Service Bulletin

Bulletin No.: PIC5675

Subject: Auto Door Lock / Unlock Feature Is Inoperative And/Or Power Locks Cycle

Models: 2012 Buick LaCrosse
2013 Chevrolet Malibu

2852028

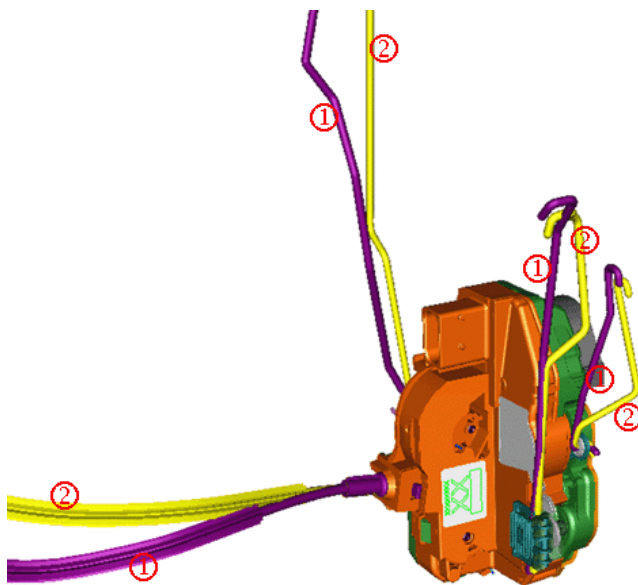
Condition: The 2012 Buick LaCrosse and 2013 Chevrolet Malibu share the same Drivers Door Latch part number, but the linkages that connect the latch to the door key lock cylinder, lock button and the external door handle are different for each vehicle. If the vehicles happen to be built with the incorrect linkage or linkages, the customer concerns may be present.

The picture below indicates the shape of all linkages. Please visually inspect linkages and compare.

LaCrosse Linkages purple (1)

Malibu Linkages yellow (2)
